RENESAS TECHNICAL UPDATE

Product Category	MPU/MCU		Document No.	TN-RZ*-A0126A/E	Rev.	1.00
Title	RZ/G2H, G2M V1.3, G2M V3.0 and G2N Addition of drivability recommendation for section 46.EthernetAVB-IF		Information Category	Technical Notification		
Applicable Product	RZ/G Series, 2nd Generation	Lot No.	Reference Document	RZ/G Series, 2nd Generation User's Manual: Hardware Rev.1.11 (R01UH0808EJ0111)		
	RZ/G2H RZ/G2M V1.3 RZ/G2M V3.0 RZ/G2N	All lots

Addition of drivability recommendation for section 46.EthernetAVB-IF

1. Section 46. EthernetAVB-IF, Page 46-334, 46.4.5 EthernetAVB-IF Drivability Recommendation is added.

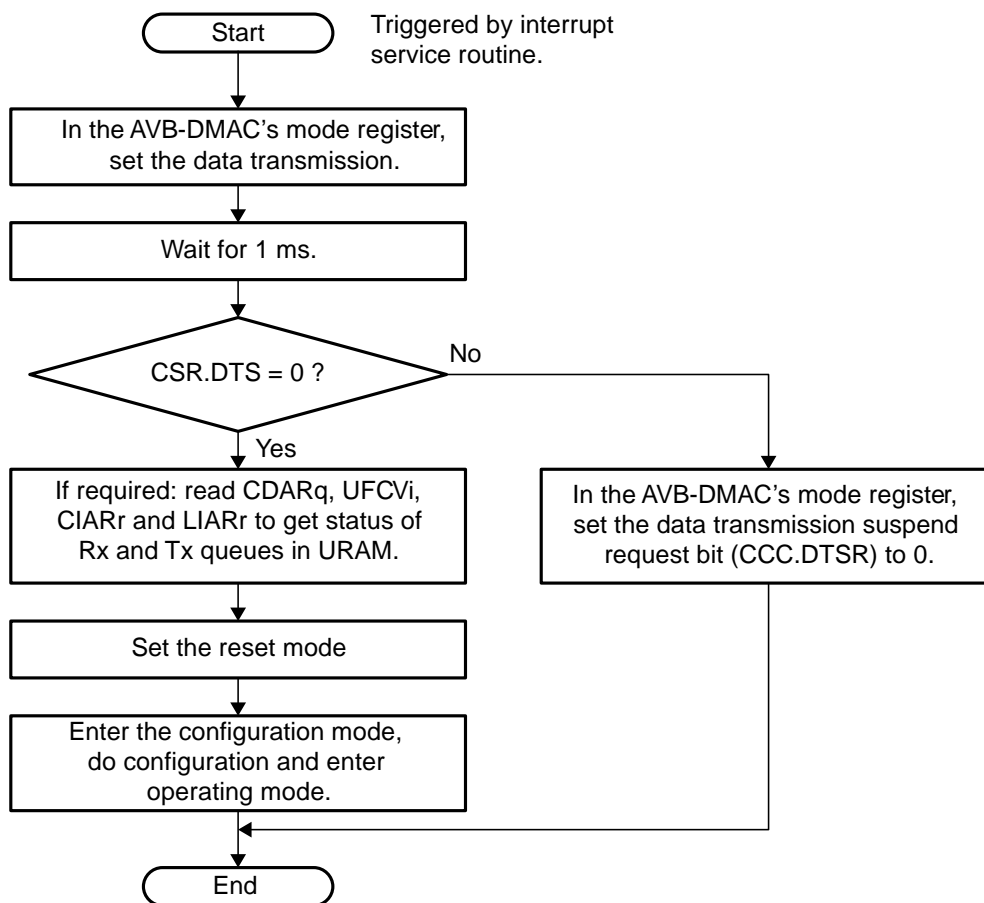
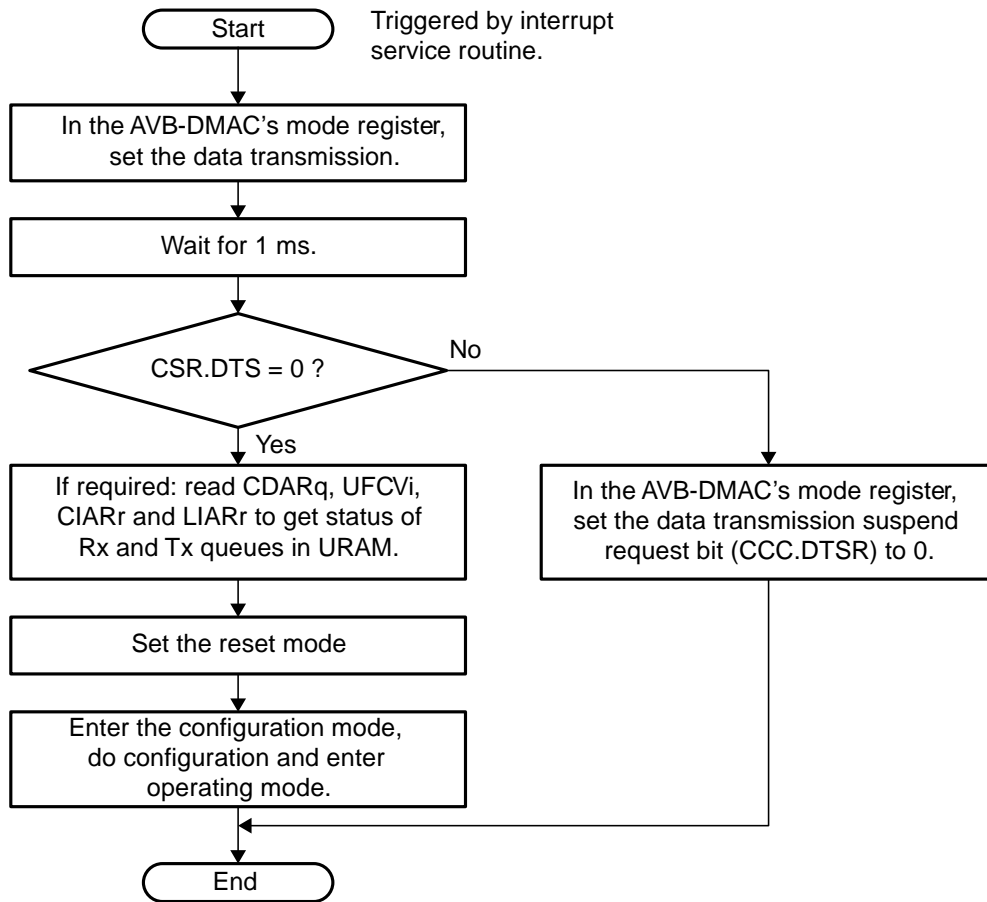
46.4.5 EthernetAVB-IF Drivability Recommendation [RZ/G2H, RZ/G2M (V1.3, V3.0), RZ/G2N]

Drivability recommendation is 5/8 (0x04). Please refer to Chapter 8. Pin function Controller (PFC) for the configuration of the Drive capability.

Addition of drivability recommendation for EtherAVB 1Gbps mode.

Possibility of rush current in IO-Buffer.
